Technical change FrontCom GFCI

- PCN-PB47-20220114-00-A
- 14.01.2022

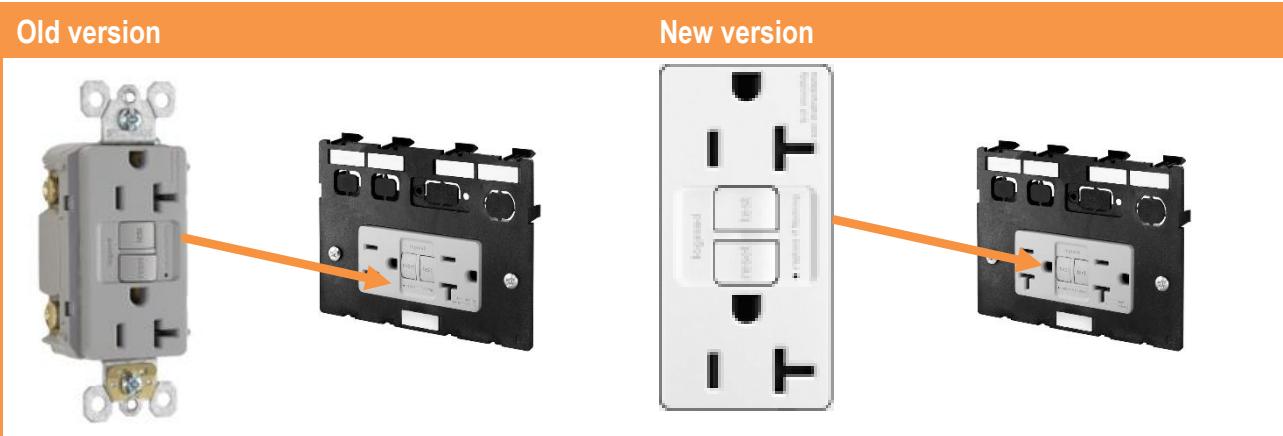
- Use of socket in grey without child safety

- The change of the collar grey to white and including child safety

- Change due to lack of material
